TOWN OF PLAINFIELD PLAN COMMISSION

CASE NO.: [RZ-26-019](#)

Project Page: Altura (Formerly Daum Farms)

REQUESTED ACTIONS: Zone Map Amendment of approximately 28.5 +/- acres from AG: Agriculture to RF: Residential Flex.

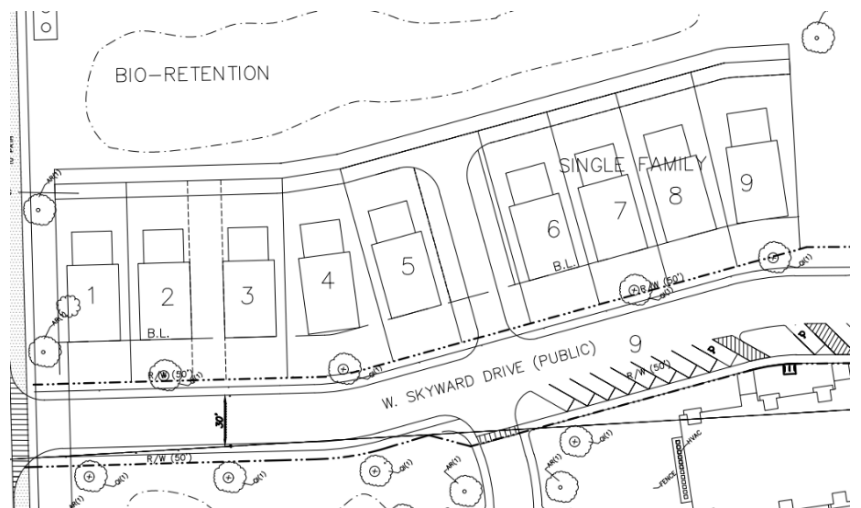
Since the previous Design Review Committee review, the applicant has substantially revised the proposed single-family housing product. The previously proposed front-loaded homes have been replaced with rear alley-loaded homes (shown below), eliminating the need for front-facing garages along the primary streets within the development.

This revised approach results in a more pedestrian-oriented streetscape, allowing front elevations to place greater emphasis on features that allow for community interaction, such as front porches, rather than garage doors.

As presented, the revised single-family product addresses staff's previous concerns regarding garage-dominant residential design and represents a development pattern more consistent with the walkable character envisioned for the community.

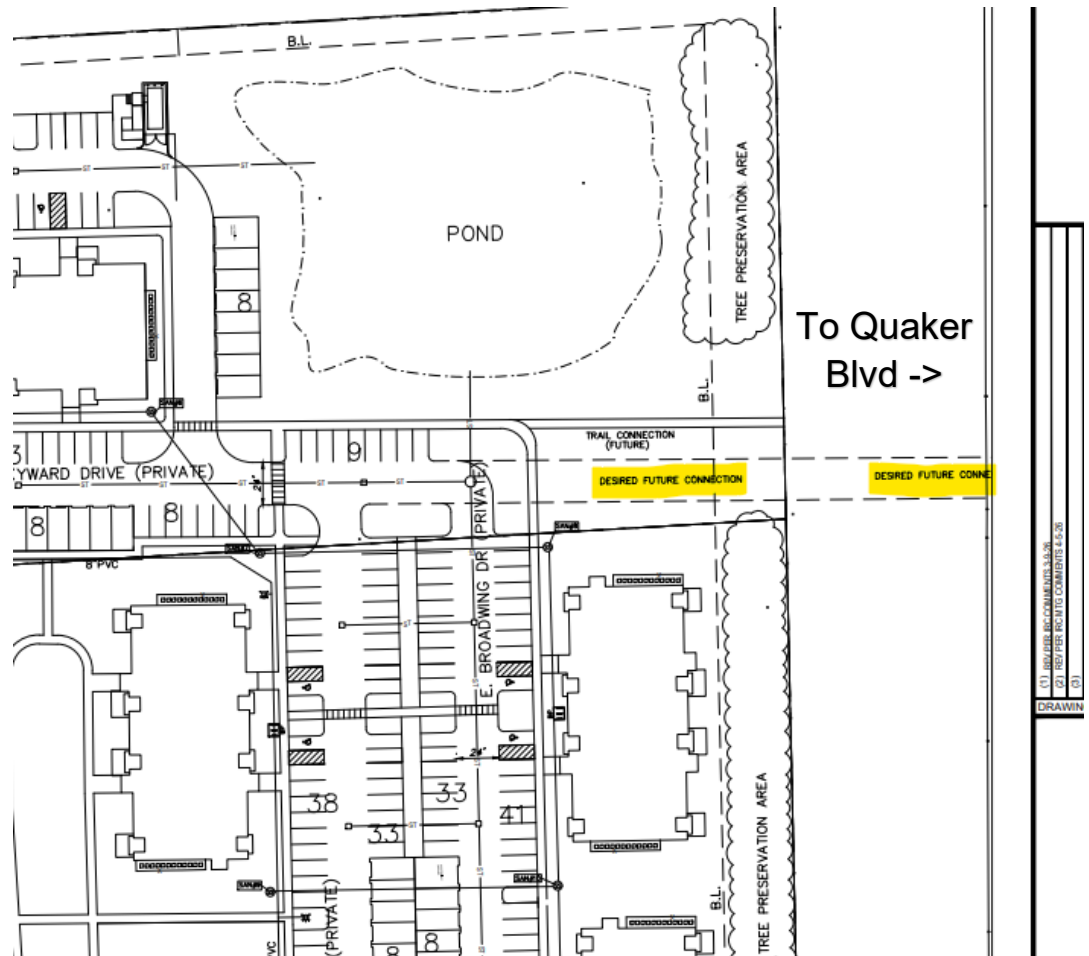
The overall site layout remains largely unchanged from the version previously reviewed by the Design Review Committee. The most notable revision is the addition of rear alleys and associated access points to serve the proposed single-family homes. These changes support the revised rear alley-loaded housing product while maintaining the overall circulation pattern and pedestrian connectivity reviewed by the Committee.

Additionally, the applicant has indicated a desired future connection from the proposed development to Quaker Boulevard in their new site plans. While no connection is proposed at this time, the location has been identified to preserve the opportunity for future connectivity.
